MOTION TO ACCEPT LATE-FILED OPPOSITION TO
MOTION TO ACCEPT LATE-FILED REPLY COMMENTS
OF GEORGIA PUBLIC TELECOMMUNICATIONS COMMISSION

**OPPOSITION TO MOTION TO ACCEPT LATE-FILED REPLY COMMENTS OF
GEORGIA PUBLIC TELECOMMUNICATIONS COMMISSION**

ENGINEERING STATEMENT

WMAZ-DT Macon, Georgia

FIGURE 1
GPTC REVISED COUNTERPROPOSAL
OET BULLETIN 69
PREDICTED COVERAGE AND INTERFERENCE
DTV Ch. 4 17 kW 304 m

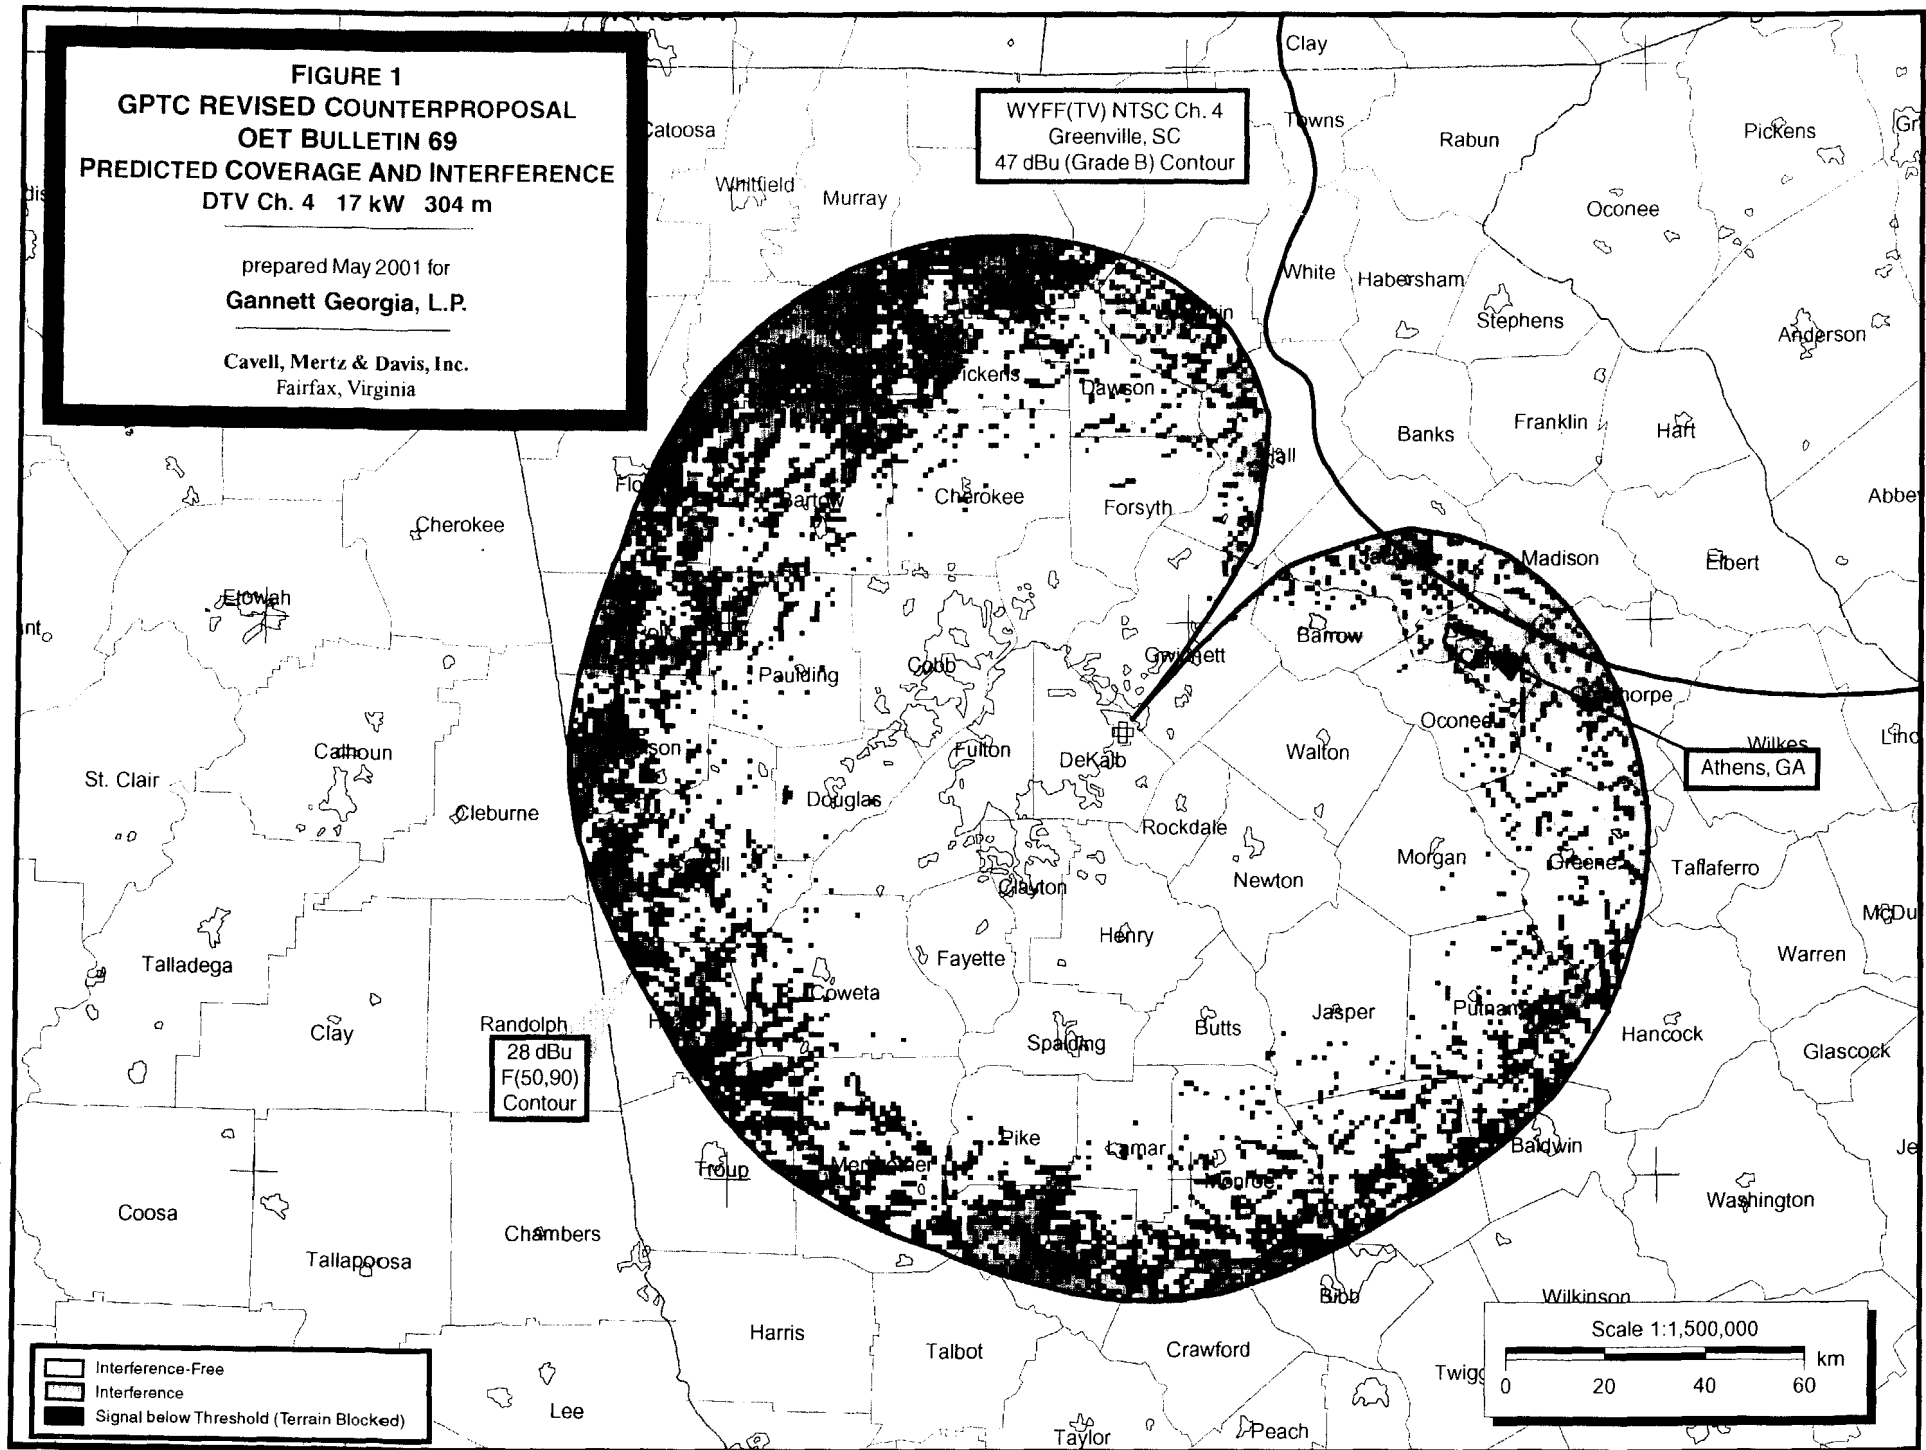
As with the original counterproposal, reception of the *GPTC* revised counterproposal facility in WGTW-DT's principal community of Athens and the surrounding area will be subject to a considerable amount of incoming interference. The attached **Figure 1** depicts the predicted coverage and incoming interference, based on OET-69. As demonstrated thereon, a significant part of the east-northeastern service area of the Channel 4 revised counterproposal would be affected by interference. Specifically, the OET-69 analysis showed that only 53.8 percent of the area and 56.9 percent of the population of Athens could enjoy interference-free reception of the revised counterproposal facility (*i.e.*, only 23.2 square km of Athens' 43.1 square km are covered, and only 26,019 of Athens' 45,736 population is covered).

Most of the interference would be caused by existing co-channel NTSC station WYFF. The original *GPTC* counterproposal also suffered from this same defect. The WYFF Grade B contour location is also provided on **Figure 1**. As shown, it passes very near Athens. The close proximity of the WYFF Grade B contour to Athens corresponds to the predictions of the large areas of predicted interference to the *GPTC* revised counterproposal facility.
